# CLASS III SERVICE INSTRUCTIONS

No. 0682-202  
ATA Code 32-00

**SUBJECT:** LANDING GEAR - MAIN GEAR ASSEMBLY - INCREASED TIRE CLEARANCE ON MAIN LANDING GEAR STRUTS

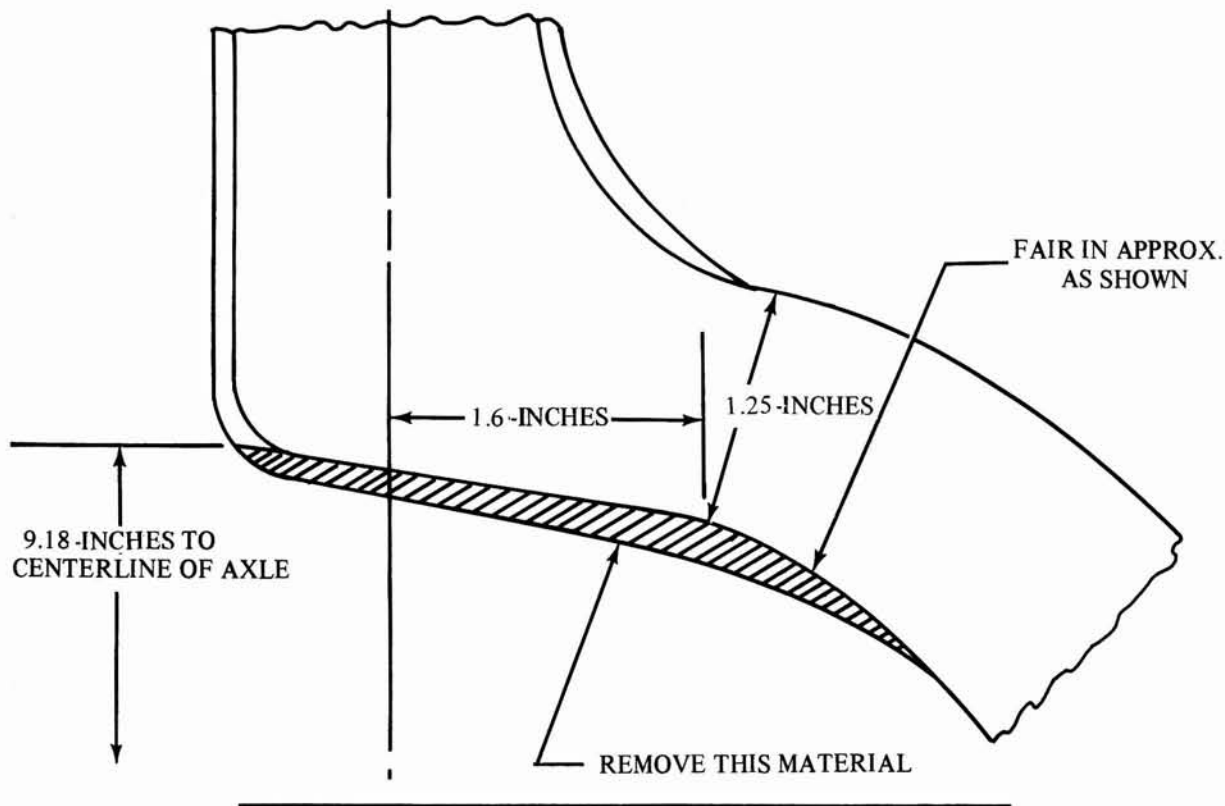
**DESCRIPTION:** The main landing gear struts are to be reworked to provide clearance for larger diameter tires.

1. Place the aircraft on jacks.
2. Remove the main gear wheels and tires from the landing gear assemblies and remove material from the main gear struts as shown in the illustration.

3. Smooth the reworked area with a fine file or sandpaper to remove all tool marks.
4. Treat the exposed metal surfaces with a chemical film treatment such as Iridite, Alodine or Chromic Acid to protect the area from corrosion.

7. Reinstall the tires and wheels on the main gear struts and check for clearance. There should be a minimum of .19-inch clearance between a new tire and the strut at the closest point.
